# UNITED STATES PATENT AND TRADEMARK OFFICE

<b>Office Action Summary</b>	<b>Application No.</b> 10/796,359	<b>Applicant(s)</b> HAWKINS ET AL.	
	<b>Examiner</b> Anu Ramana	<b>Art Unit</b> 3775

- 1) ☒ Responsive to communication(s) filed on 18 December 2008.
- 2a) ☒ This action is **FINAL**. 2b) ☐ This action is non-final.
- 3) ☐ Since this application is in condition for allowance except for formal matters, prosecution as to the merits is closed in accordance with the practice under *Ex parte Quayle*, 1935 C.D. 11, 453 O.G. 213.

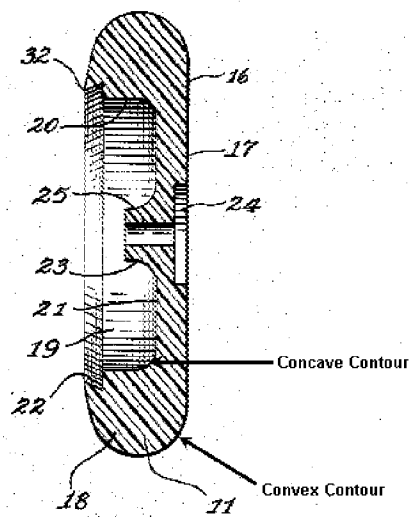
Claim 44 is rejected under 35 U.S.C. 102(b) as being anticipated by Duncan, Jr. (US 3,805,443).

Duncan, Jr. discloses a device including: a central body 12; a first extension 10 separate from the central body; a second extension 11 separate from the central body; and a rivet 13 wherein a first portion of the rivet is integral with one of the extensions and a second portion of the rivet is integral with the other of the extensions wherein the rivet is located in a lower half of the extensions (Figs. 2 and 6, col. 1, lines 37-68 and col. 2, lines 1-67). Note that the rivet is in the lower half of the extensions wherein the lower half is defined by a longitudinal axis of each extension. Also, see marked up Fig. 3 from Duncan, Jr. below.

As previously discussed, Duncan, Jr. clearly discloses first and second extensions, each extension having an upper end, a lower end, an inner surface having a convex contour and an outer surface having a concave contour as illustrated in marked up Fig. 3, provided earlier in this action.

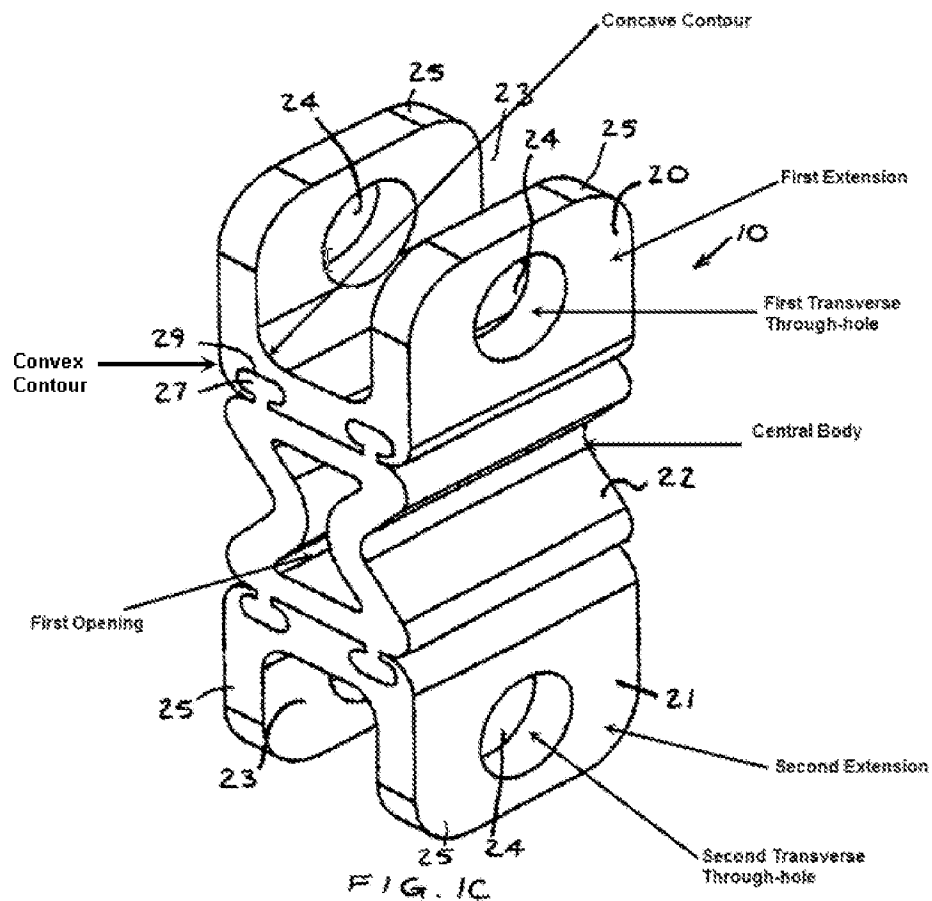
Claims 28-30, 44 and 46-48 are rejected under 35 U.S.C. 102(e) as being anticipated by Arnin et al. (US 7,011,685).

Arnin et al. disclose an interspinous implant including a central elastomeric body 22, a first extension 20, a second extension 21, and a rivet passing through a hole 24 in the first extension and thus having a first portion integral with the extension and a rivet passing through a hole 24 in the second extension (Fig. 1C, col. 3, lines 42-67 and col. 4, lines 1-36). Arnin et al. disclose the extensions to be made of titanium. It is noted that a rivet inherently has a male part or pin and a female part or pin. See marked up Fig. 1C from Arnin et al. on the following page.

As previously discussed, Arnin et al. clearly disclose extensions, each extension having an inner concave contour and an outer convex contour.
